MARK	DATE	DESCRIPTIONS	BY	CH'D	CCO#
0	05/13/11	SKYWAY BIKEPATH RAILING MODIFICATIONS	AE	JB	179

SAN FRANCISCO OAKLAND BAY BRIDGE
EAST SPAN SEISMIC SAFETY PROJECT

SKYWAY CLEANUP ITEMS

BIKEPATH EMERGENCY GATE DETAILS NO. 2

NEW GATE RETAINER
1:3
(2 require each gate at same location as Exist gate retainers)

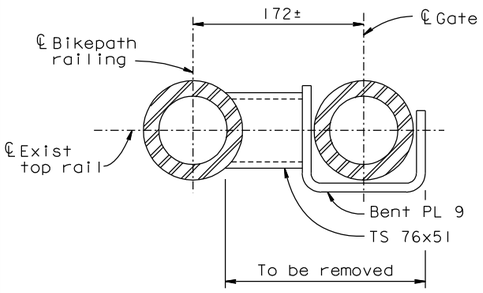
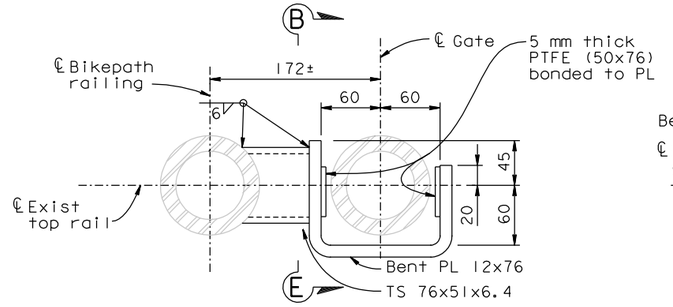
EXISTING GATE RETAINER (2 each gate)
1:3

NEW GATE LATCH PLATE
1:3
(2 require each gate at same location as Exist gate latch plates)

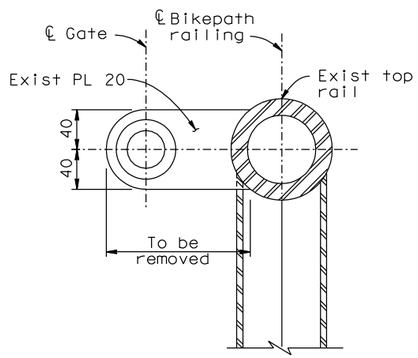
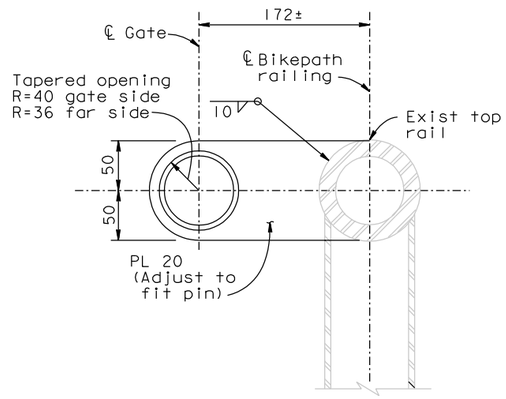
EXISTING GATE LATCH PLATE (2 each gate)
1:3
